**Review of the
Bowers Wind Project
Visual Impact Assessment**

Scenic Quality Consultants
Burlington, Vermont

Prepared for
Maine Land Use Regulation Commission
Augusta, Maine

June 3, 2011

ArcScene Visualization 1: Bottle Lake

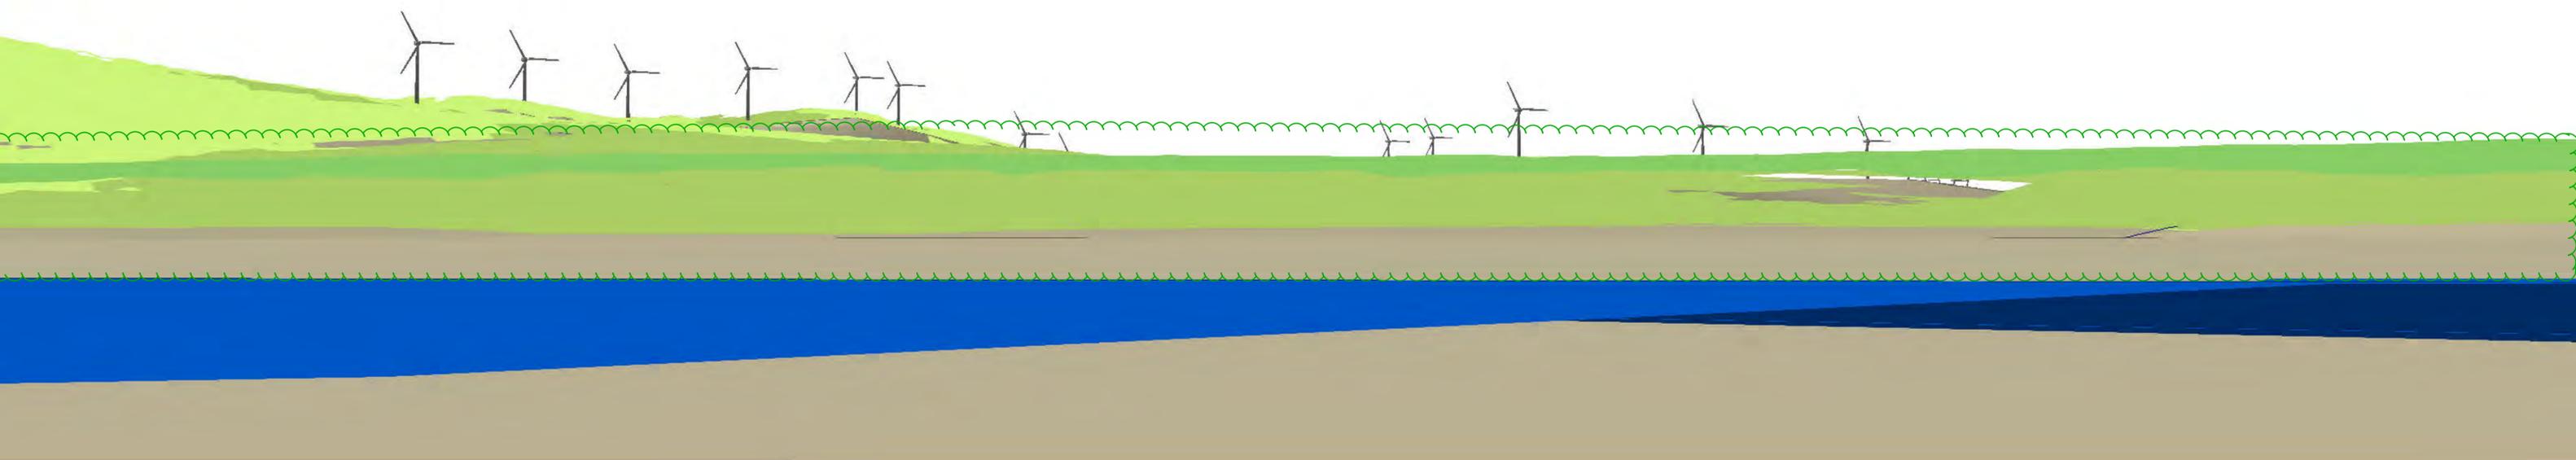
Bottle Lake. The scope and scale of Visualization 1 is very similar to the photosimulation in the VIA's Exhibit 6. This supports the accuracy of the photosimulation.

ArcScene Visualization 3: Junior Lake

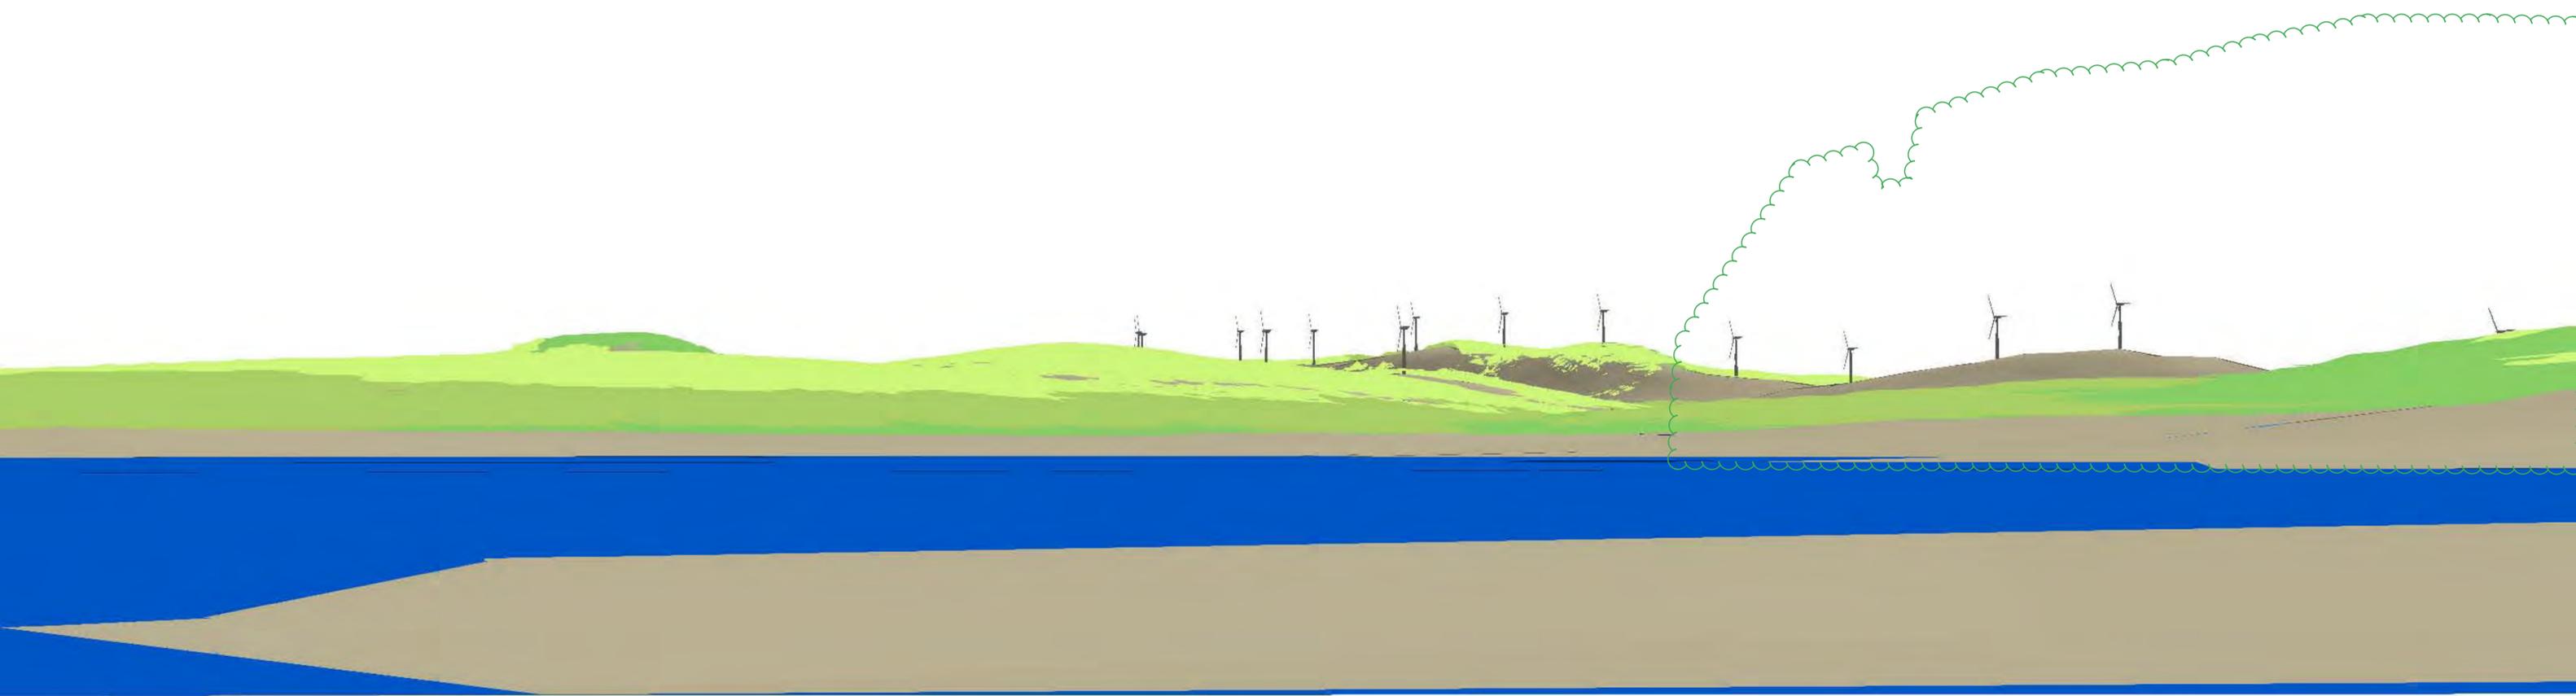
Junior Lake. The scope and scale of Visualization 3 is very similar to the photosimulation in the VIA's Exhibit 8. This supports the accuracy of the photosimulation.

ArcScene Visualization 6: Pleasant Lake, Near Northern Shore

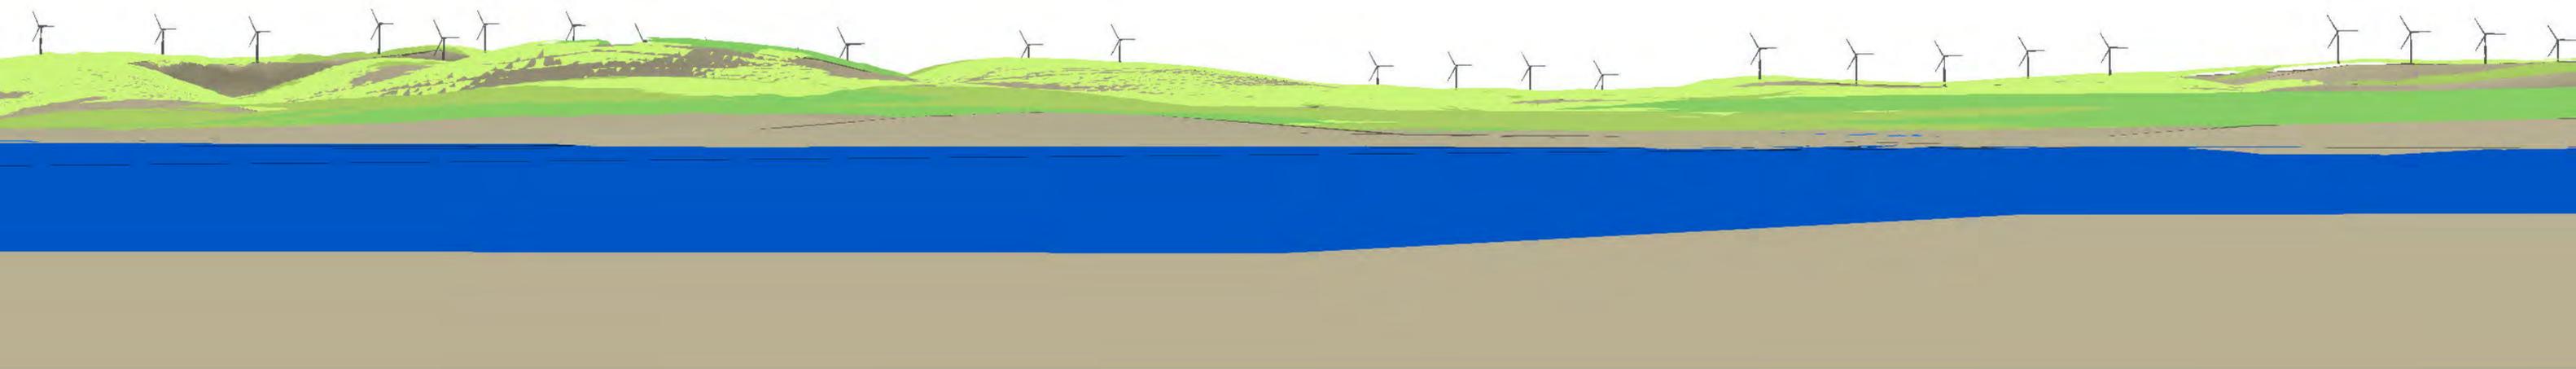
Pleasant Lake, Near Northern Shore. The scope and scale of the left and center portions of Visualization 6 is very similar to the photosimulation in the VIA's Exhibit 11. This supports the accuracy of the photosimulation. However on the right portion there are turbines apparent in the visualization that are screened in the photosimulation. This is because near-by shoreline vegetation not represented in the visualization will screen the turbines. An approximation of the area that is screened by the shoreline vegetation is outlined by a scalloped green line in the visualization. Considering this adjustment to the visualization, the whole photosimulation appears to be accurate.

ArcScene Visualization 7: Scraggly Lake

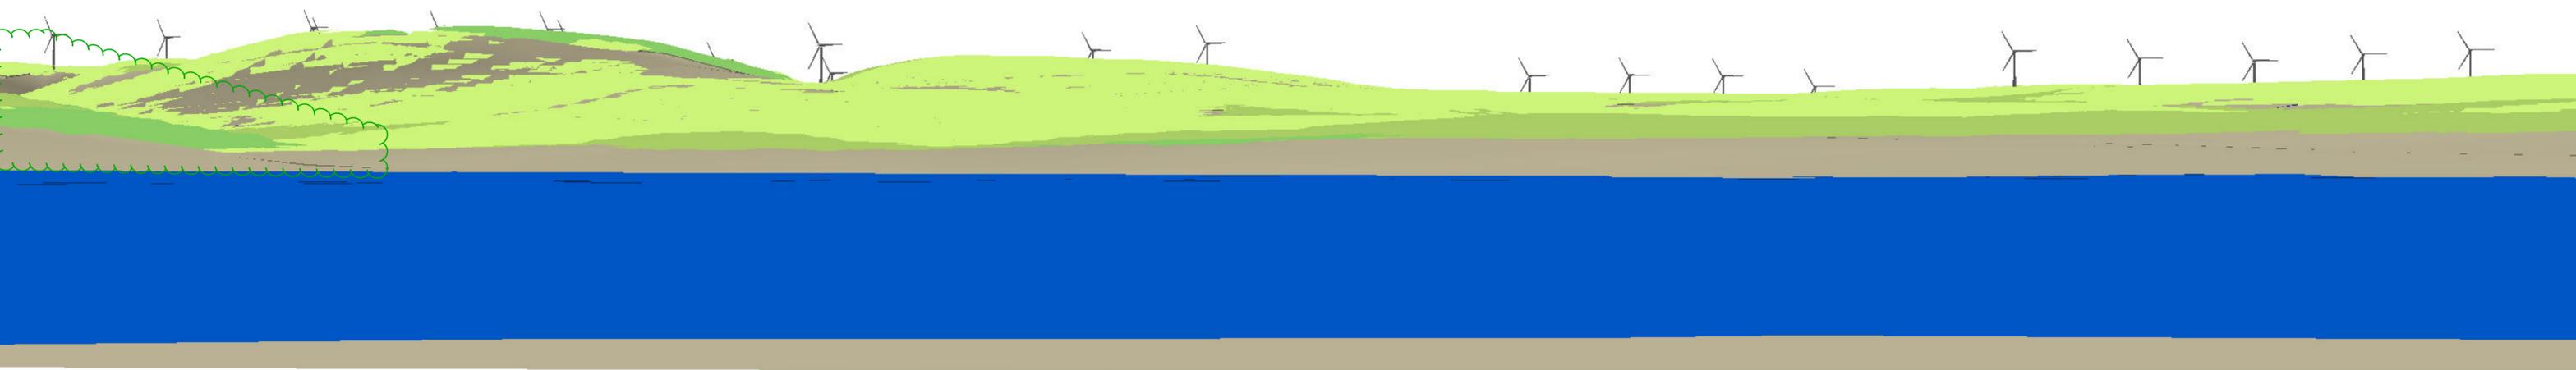
Scraggly Lake. The scope and scale of Visualization 7 is very similar to the photosimulation in the VIA's Exhibit 11. While the shoreline vegetation in the photograph is slightly higher than shown on the right side of the visualization, this will not significantly change the visual exposure of the turbines from this viewpoint. This supports the accuracy of the photosimulation.

ArcScene Visualization 8a: Shaw Lake

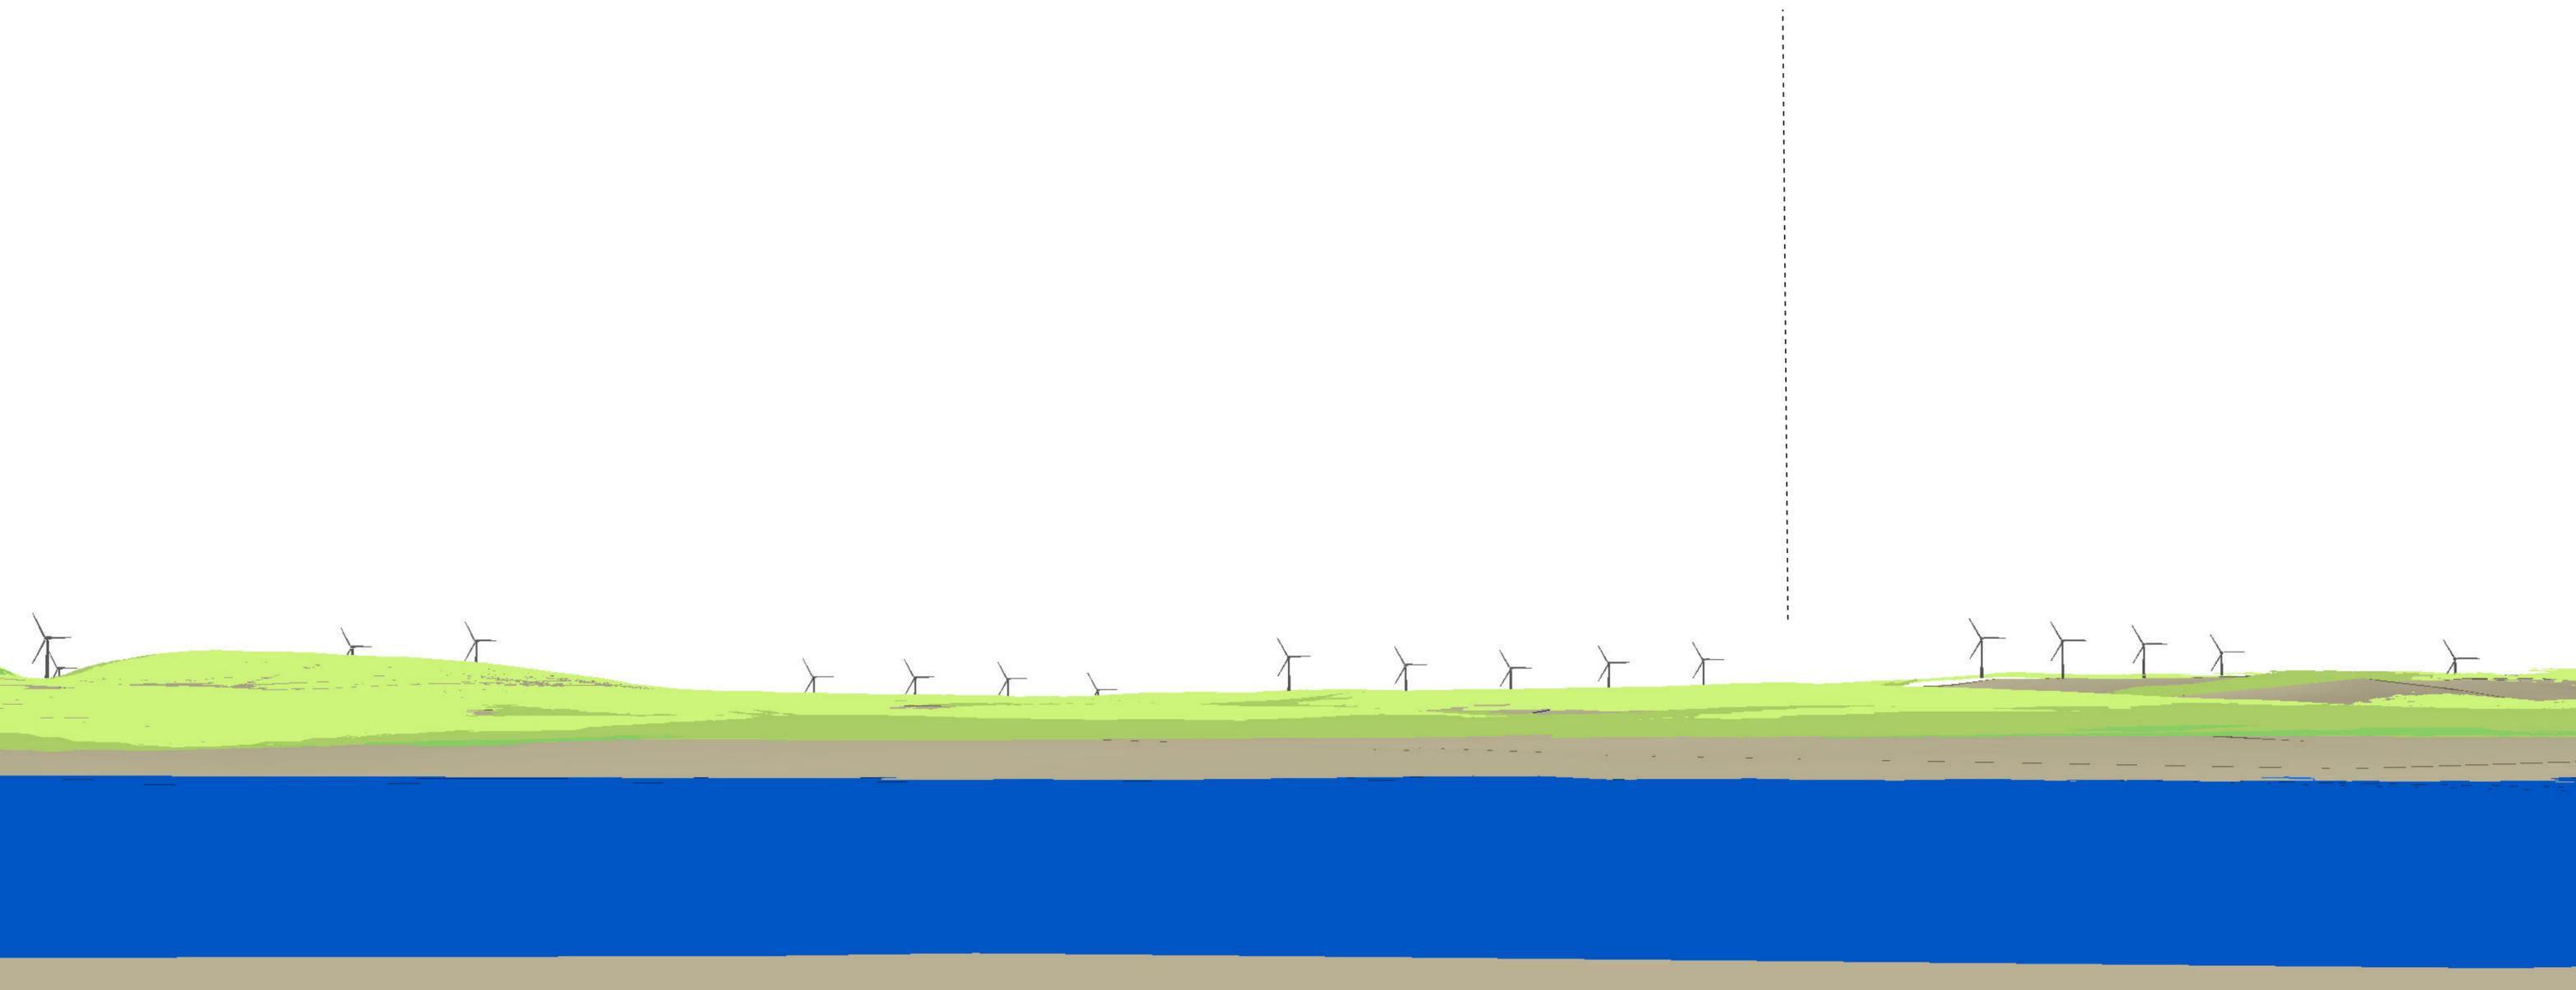
Shaw Lake. The scope and scale for most of Visualization 8a is very similar to the photosimulation in the VIA's Exhibit 13. However, shoreline vegetation will screen one turbine on the far left. This supports the accuracy of the photosimulation. Another issue concerns whether the photosimulation is too narrow to show all of the turbines that may be visible to the right. The photosimulation only extends on the right to turbine 22 and there is the possibility that turbines 23 through 27 are also visible to the right of the photosimulation, as illustrated in Visualization 8b: Shaw Lake.
